SUBMISSION - NORTHCONNEX

NorthConnex EIS Submission

NorthConnex Application Number: SSI 13_6136

Figure 9 Predicted tunnel traffic flows – northbound

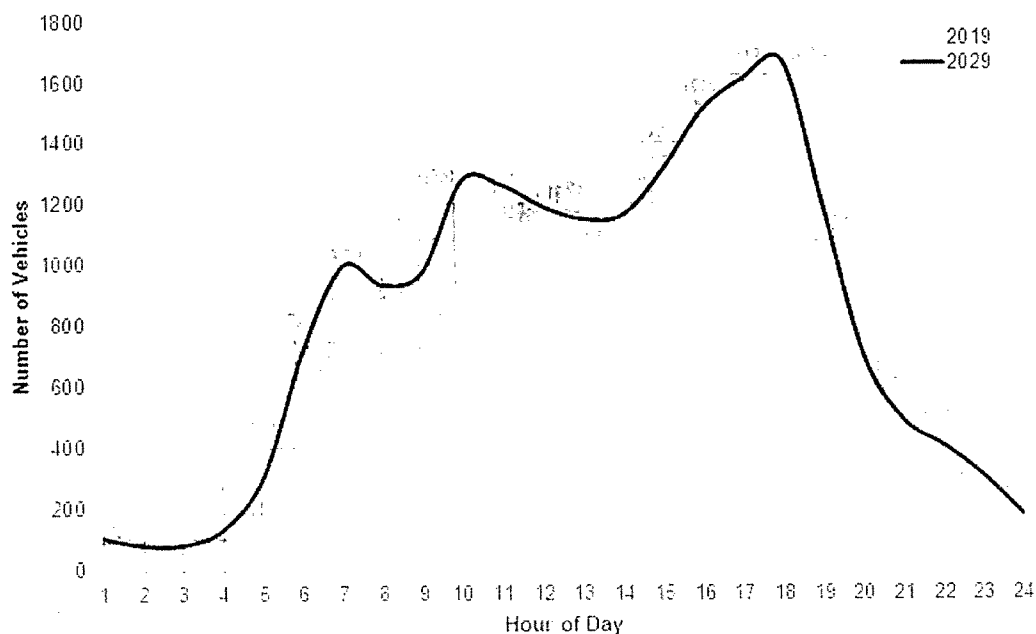
NorthConnex Project overview clearly states that the NorthConnex would take 5,000 trucks off Pennant Hills Road each day, and it would have capacity to carry more than 100,000 vehicles per day (50,000 in each direction). However the EIS emission calculation misleadingly used the figure of 19,500 vehicles per day per direction as the basis for their calculation. Refer to Appendix A for the handwritten calculations in relation to the EIS "Predicted tunnel traffic flow –northbound" in 2029.

In my professional opinion, the EIS vehicle emission has been underestimated by using the figure of 19,500 daily vehicles in lieu of 50,000 daily vehicles. Therefore, the purported EIS calculation is not only unreliable but raises the concern whether it accurately includes the "5,000 [daily] trucks off Pennant Hills Road".

NOTE: A SUMMARY OF UNDER SHARED DATA FOR 2019 = 17500 VEHICLES/DAY
WHICH IS FAR LESS THAN THE TUNNEL CAPACITY 50,000 VEHICLE/DAY

ALTERNATIVE TUNNEL LONGITUDINAL SECTION

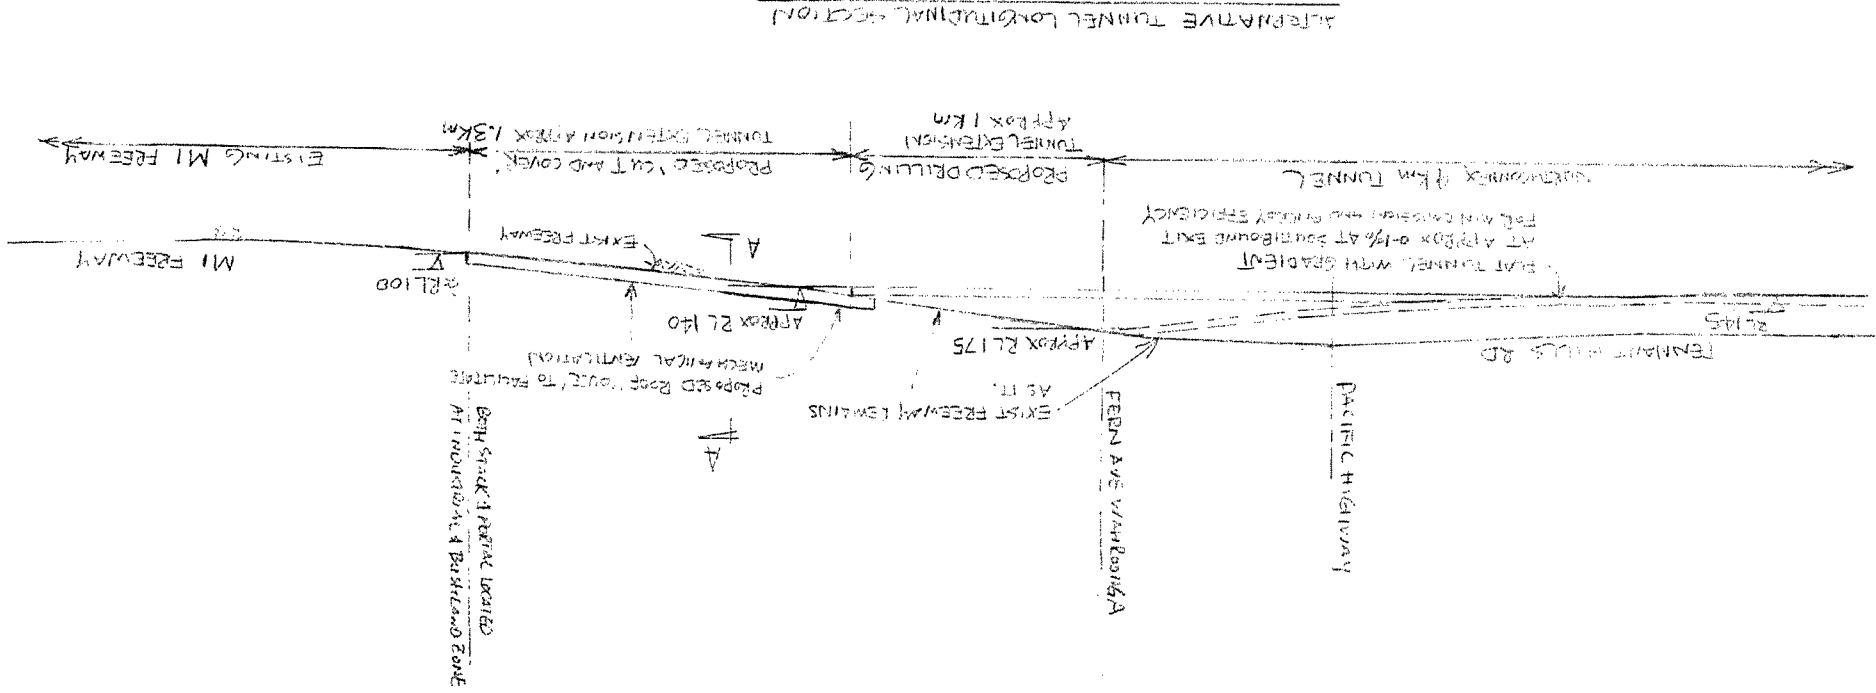
Importantly, I would like to propose an alternative 'cut & cover' tunnel extension & relocate Northbound portal & stack into bush land & industrial zone, please find the attached "Appendix E- Alternative 'Cut & Cover' Tunnel" design sketch for your consideration. I have briefly listed some advantages of my alternate design below:

- Flat tunnel to minimize emission & increase energy efficiency which ought to be in the NorthConnex first instance. Therefore I propose the last portion of Northbound tunnel to be as flat as possible to avoid any vertical bend in the transition zone between the driving & 'cut & cover' tunnels. This has should be a lesson learnt from the design mistakes in the M5 Tunnels.

- Use the 'cut & cover' concept to further extend Northbound portal & stack into industrial & bush land zone.
- Basically use existing freeway as a tunnel base & build walls/roof 'cover' to facilitate mechanical ventilation or rooftop for landscape/solar energy.

SECTION A-A
AT 'CUT & COVER' TUNNEL
1:200

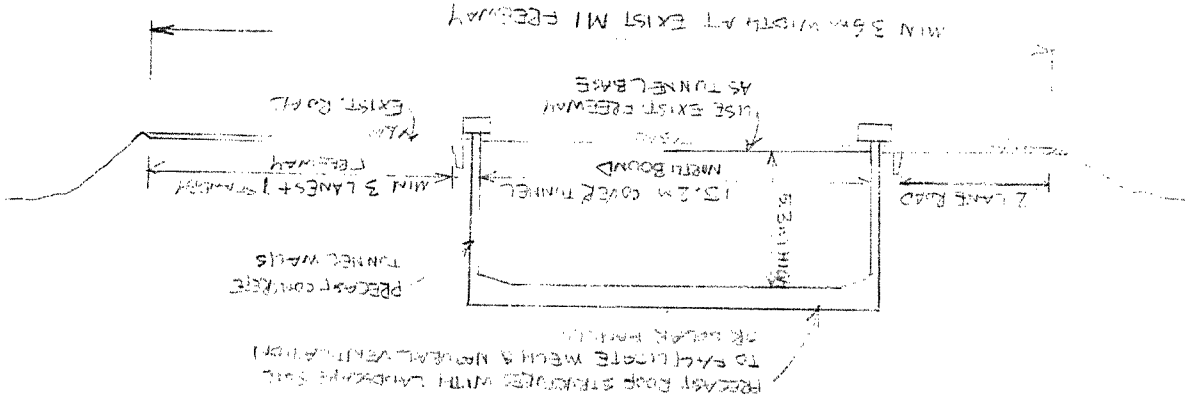
- Existing freeway at North Wahroonga has sufficient minimum 36m width to accommodate the 'cut & cover' tunnel in the middle of aisle as shown on section A-A, and provide advantage to access tunnel at side walls for all fire emergence(EIS does not consider currently).

- The precast walls & roof structures could be 1/4 cost of drilling tunnel per km, the structural cost of 1.3km 'cut & cover' tunnel could be about \$50million, which provides budget allowance to keep all Northbound portal/stack away from residential zone.
